DECISION OF THE PLANNING ADMINISTRATOR

URBAN GROWTH AREA PRELIMINARY DECLARATION / SITE PLAN REVIEW / DRIVEWAY APPROACH PERMIT CASE NO. UGA-SPR-DAP17-05

SUMMARY: Urban Growth Area Preliminary Declaration to determine requirements for public facilities and a site plan review for phased development consisting of (Phase 1) mass grading and paved lot for auto display and sales, (Phase 2) drive-through coffee shop, and (Phase 3) future auto dealership.

LOCATION: 700 Auto Group Avenue NE / 97301

DRAWING
C3.0
JOB NUMBER
2921.0000.0

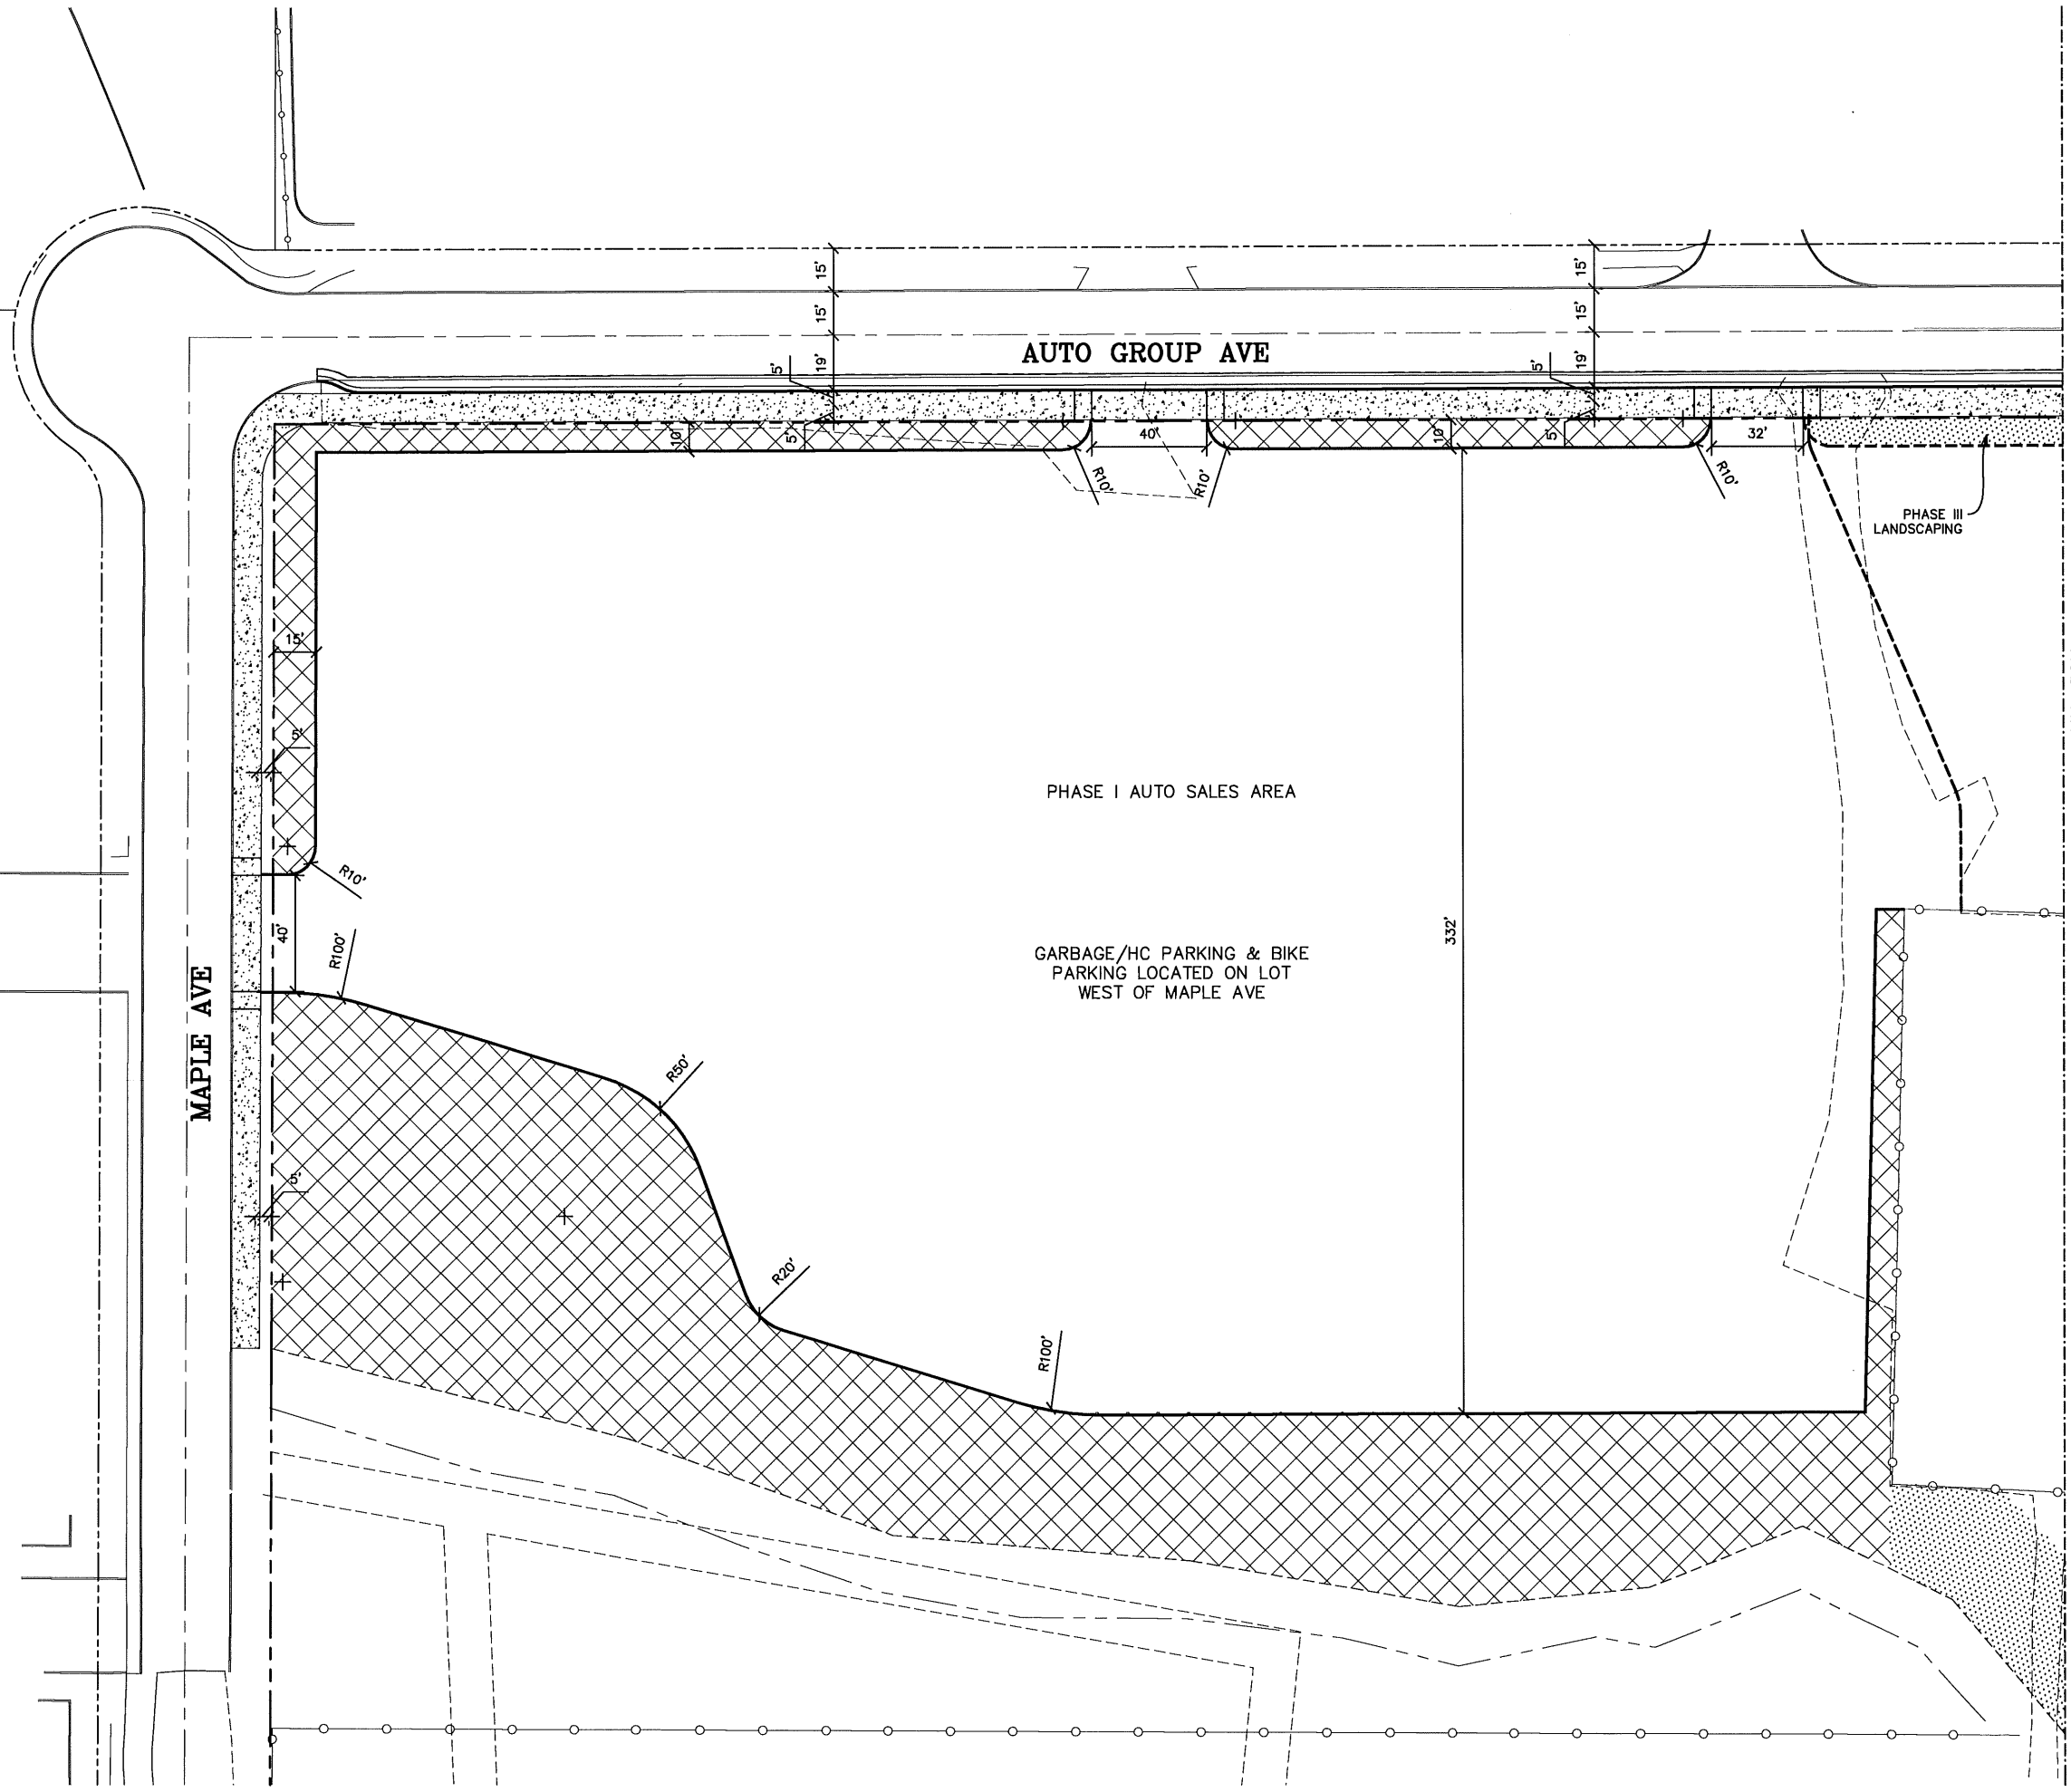
1. The Maple Winter bikeway plan (draft) shows a 5' buffer strip between the street and the 10' path along much of the street frontage for this property. The plans seem to show a curb-tight sidewalk.

3. How will it be clear that this is a multi-use path and not just a wide sidewalk? How will people on bikes be directed to the path? How will the path/sidewalk be treated as it crosses the driveways? I would like for the path grade to be maintained across the driveways, not dip down to the level of the driveway. A raised crossing would be great. Any signs or pavement markings proposed?

There are a lot of details related to the path's crossing at Cherry Ave that are not shown in the plans. How will the signal be modified? How will pavement markings be applied? How will bicycles be accommodated? Will a bike signal be added? Bike detection? If none of those details have been worked out, how about considering something like a protected intersection in just the SW quadrant or maybe some other option? The protected intersection concept would require bicyclists to make a "Dutch left" but it would not be as nearly disruptive to the signal operation as a diagonal bike phase would be. Chicago has a nice example of the use of the protected intersection concept in just one corner at Washington and Franklin.

4. Does the developer want to delay all of the landscaping associated with Phase 1 (dealership parking lot) and Phase 2 (coffee drive-thru) until Phase 3 (future dealership), so there would be no landscaping between the sidewalk and the parking lot until the dealership is built?

Finding: Bicycle parking is not clearly indicated on the site plan. The following condition is required to ensure compliance with these standards:

No pedestrian connection is indicated on the site plan from the public sidewalk to the proposed eating and drinking establishment in Phase 2. The following condition is required so that pedestrians are not forced to share the driveway with vehicles:

Staff Response: The conditions of approval require the shared use-path to be constructed a minimum of 4.5 feet from the face of the curb.

Staff Response: The conditions of approval specify the applicant's responsibilities for the shared-use path. The City will complete necessary modifications of the Cherry Avenue NE/Auto Group Avenue NE intersection and signal as part of the Winter-Maple Family-Friendly Bikeway project. The Final Draft of the plan is pending Council acceptance.

Staff Response: With Phase 1, the applicant is proposing to landscape around the Phase 1 auto sales area and to seed the remainder of the property after it is graded. With Phase 2, additional landscaping would be provided north and east of the coffee drive-through. With Phase 3, the remaining landscaping would be provided around the perimeter of the auto dealership. Because the landscaped areas must be irrigated, and irrigation systems must be incorporated into parking lots and other paved areas, it would be difficult to provide full landscaping before Phases 2 and 3 are developed.

Condition 7: With Phase 2, provide four bicycle parking spaces meeting the standards of SRC 806.060.

Condition 15: With Phase 2, provide a paved sidewalk on the west side of the driveway from the public sidewalk to the private sidewalk shown on the site plan.
